STATE OF MICHIGAN

DEPARTMENT OF NATURAL RESOURCES
LANSING

SUBJECT: Response to RAI – August 27, 2004, Tobico Marsh State Game Area Site
and Submission of Additional Information Relative to the Decommissioning Plan
Docket No. 40-9015, License No. SUC-1581

MDNR Response to Specifically Identified RAIs

Figure 9-2 Decommissioning Management Positions

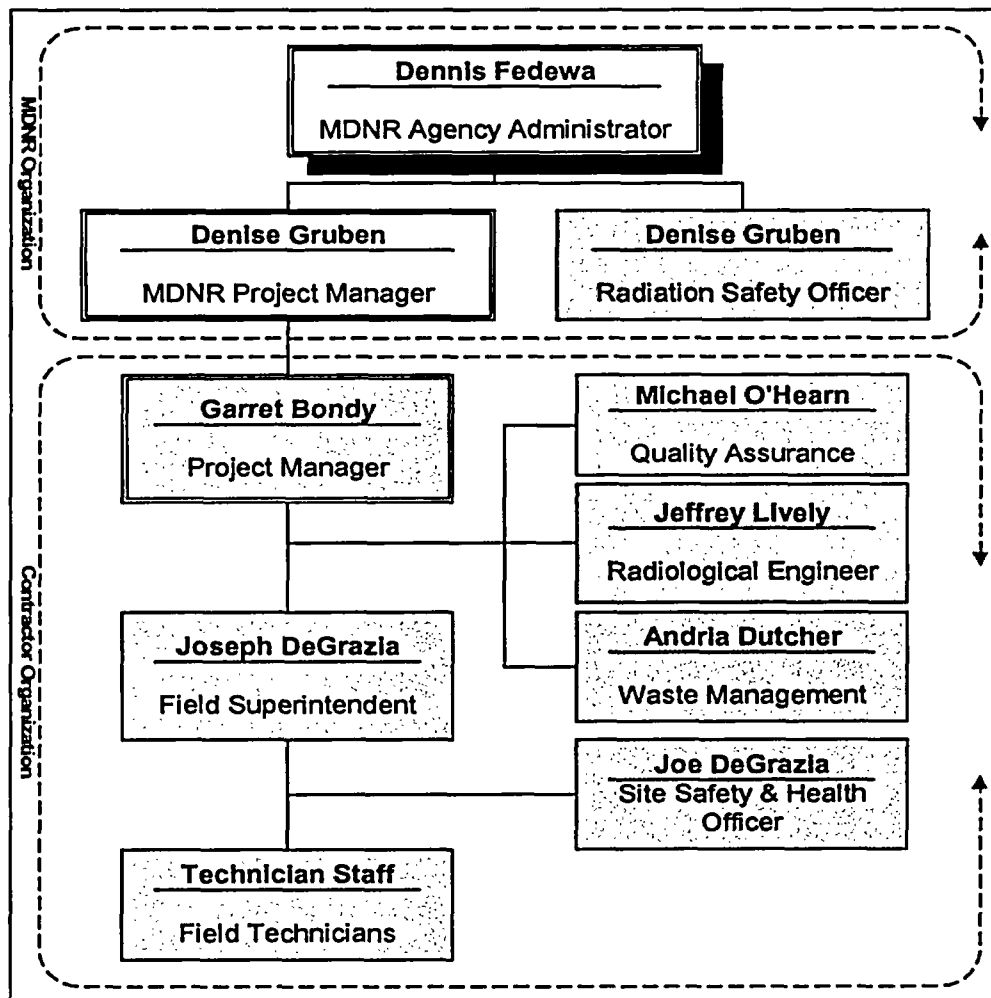
Figure 9-2, Page 9-5, (Organization Chart). A revised organization chart is provided to reflect personnel changes in key management positions.

Figure 1 Cumulative Probability for Annual Radiation Dose, All Pathways, LCTS leakage Scenario

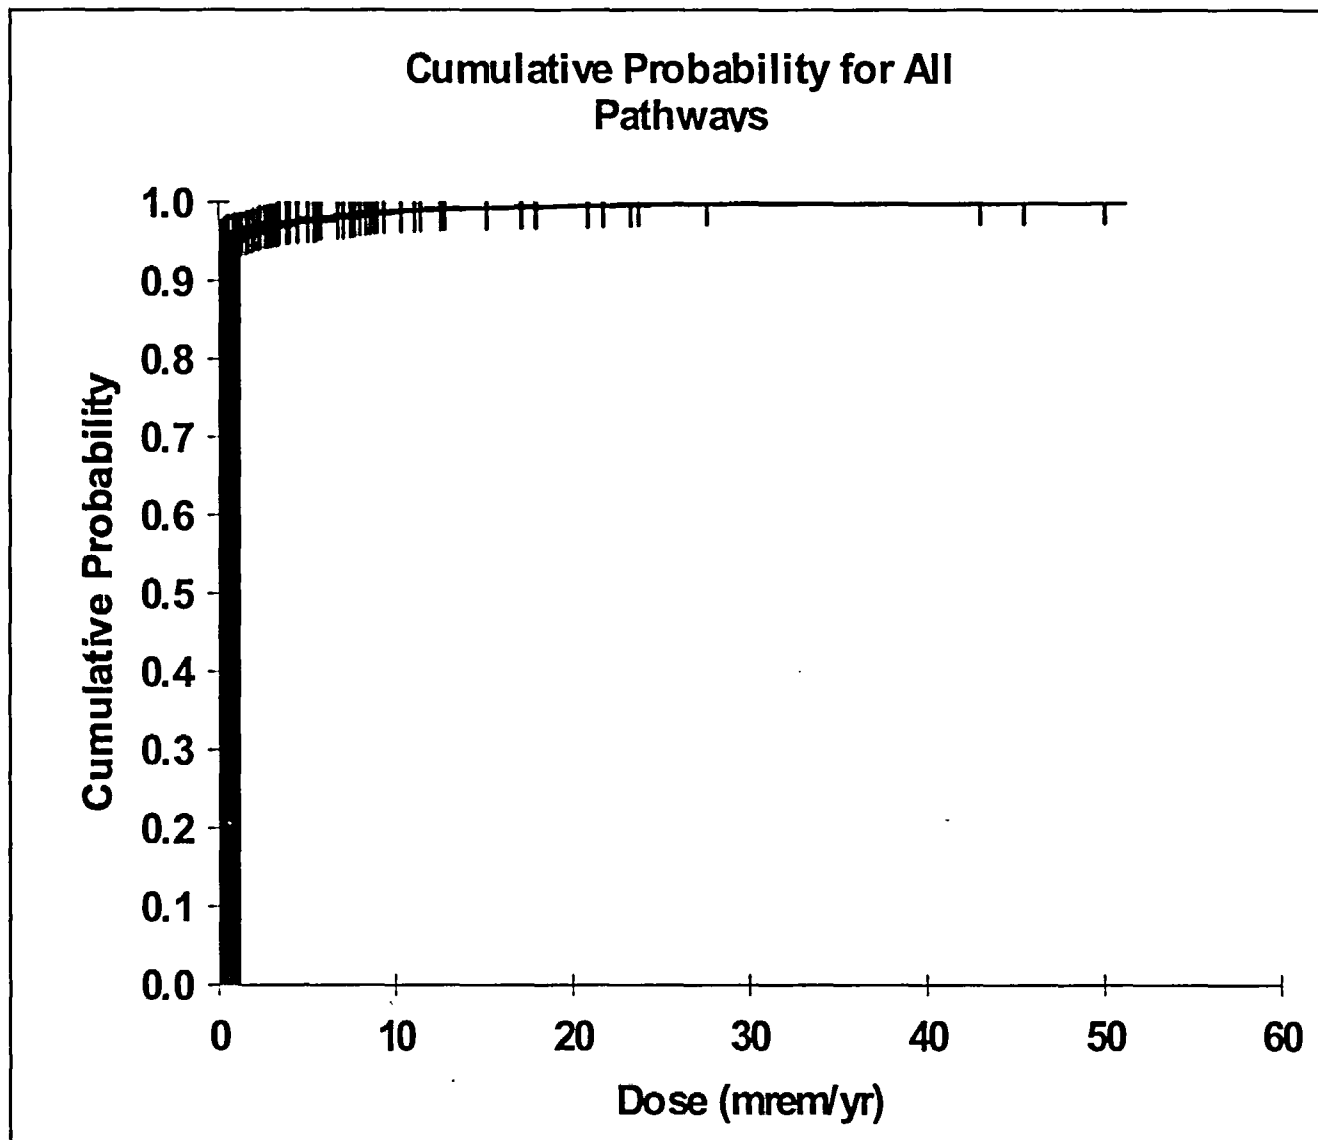
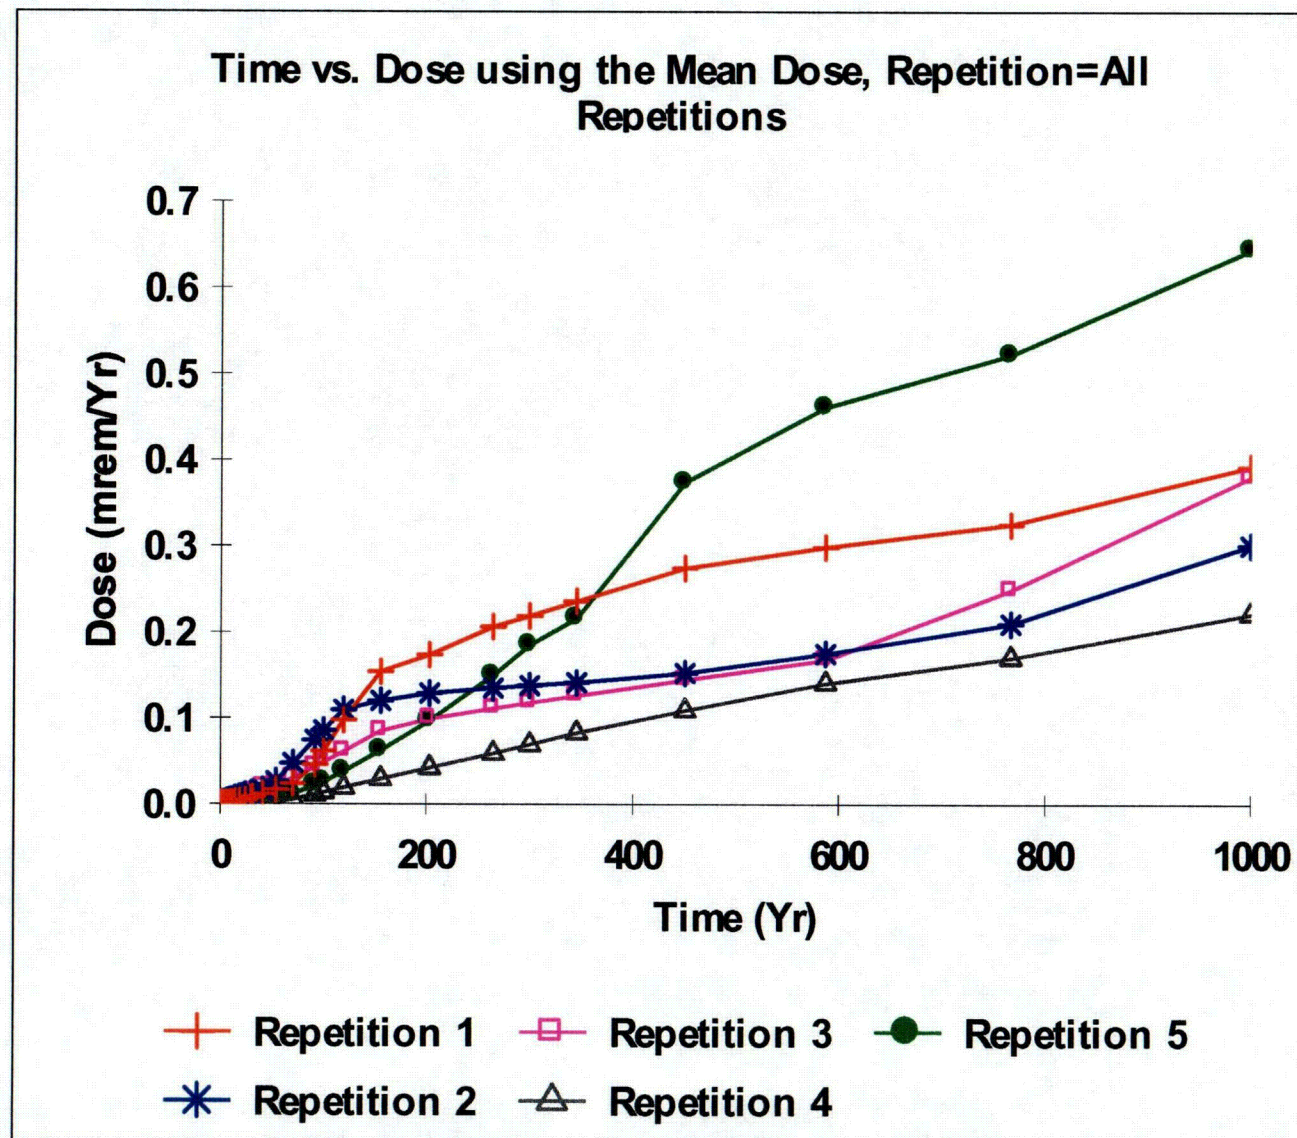
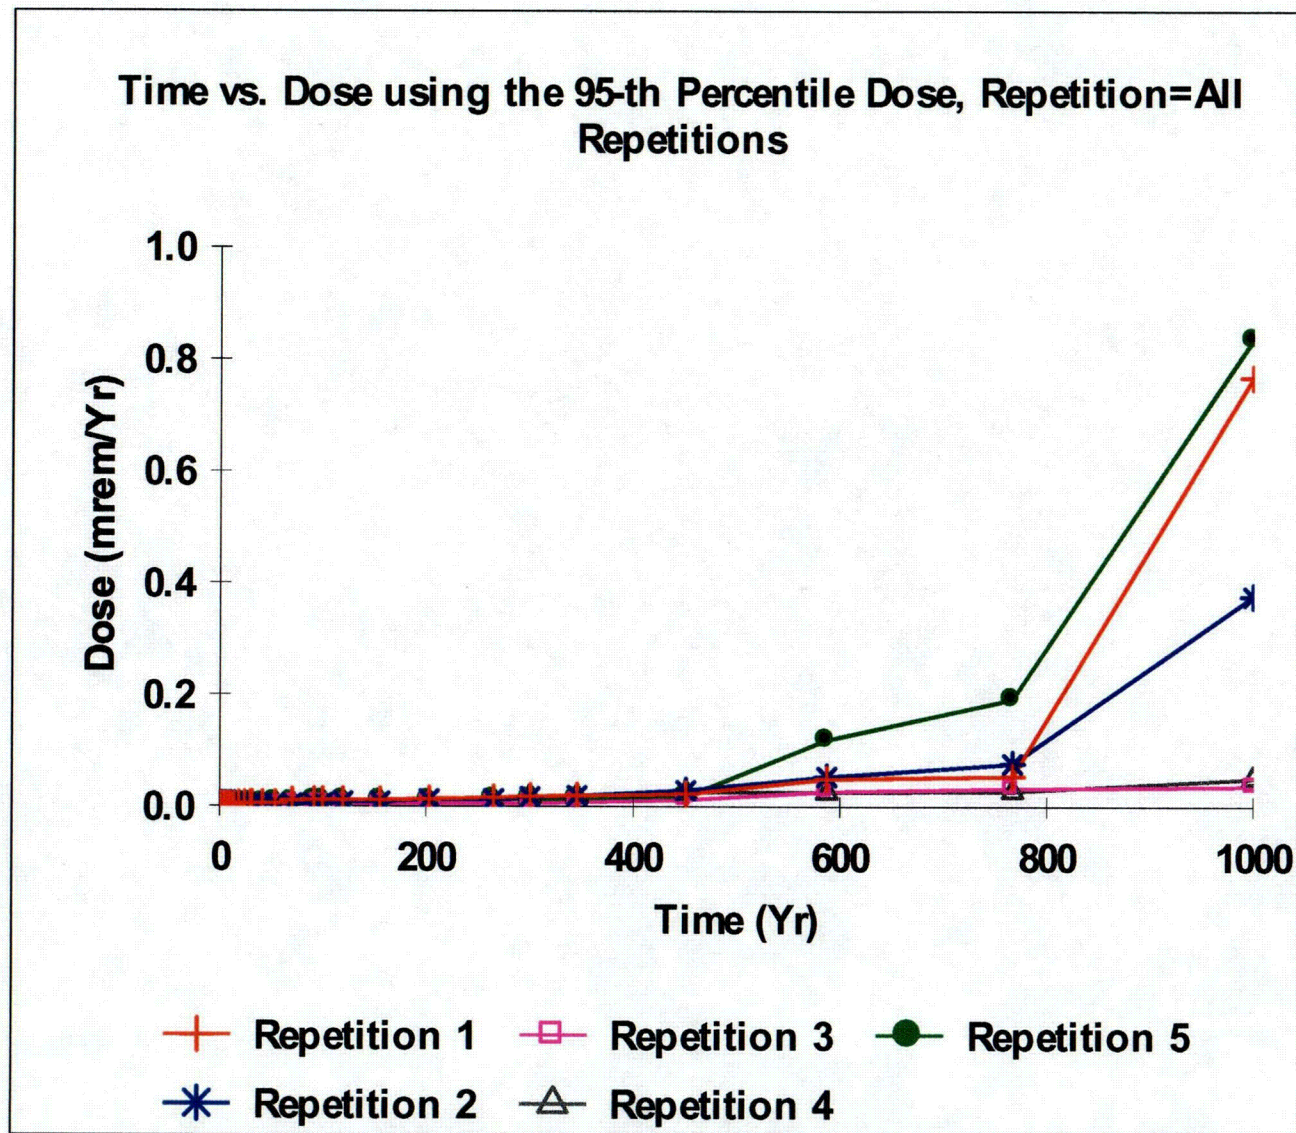
RAI#2 With regard to the waste cell, it is conceivable that if the LCTS is disabled, sufficient hydraulic pressure could build within the cell causing leakage of leachate. Provide additional information to ensure that disabling the LCTS System will not lead to leakage of leachate contaminated with thorium and/or its daughter products.

Requested Additional Information: Since MDNR had anticipated that the LCTS system would be decommissioned as part of the license termination process, no scenario involving "operational leakage" was previously evaluated to quantify the potential radiation dose to those that might be exposed to radioactivity stemming from leaks in the LCTS system should it remain in place and become operational. As described in its response to RAI #2, MDNR is convinced that the leachate is not adversely impacted with elevated concentrations of residual radioactivity associated with currently licensed materials. Nonetheless, MDNR understands the need to demonstrate that future operation of the LCTS (should it ultimately be left in place) will not pose an unacceptable radiological dose to those who may be exposed to the leachate.

The potential future dose arising from "contact" exposure pathways (i.e., ingestion, inhalation, etc.) associated with future operation of the LCTS result from incidental contact with the leachate. The potential radiation dose from a worker's or visitor's *incidental contact* with the leachate is reasonably bounded by the "system leakage" scenario described in response to RAI #3. In that scenario, the only "contact" pathway that results in a potential radiation dose is the consumption of aquatic foods, an activity not likely to be engaged in by workers or visitors to a site involved in landfill leachate collection operations. Consequently, MDNR concludes that there is insignificant potential for radiation exposure via the "contact" pathways.

MDNR again chose to perform a conservative bounding calculation to assess the potential future dose requested by the NRC. While it is considered an unlikely prospect, based upon conversations with representatives of S.C. Holdings, MDNR's dose assessment assumes that a large leachate-holding tank will be installed at the site. (Note: S.C. Holdings indicated to MDNR that their plan is to pipe leachate extracted from the MDNR cell directly to a single, common leachate collection/processing facility located at on the Waste Management Site property.) The assumption that a large leachate-holding tank will be installed at the MDNR site is bounding in that it represents a potential source term far larger than would be possible with above ground piping or other smaller vessels and containers that might be envisioned.
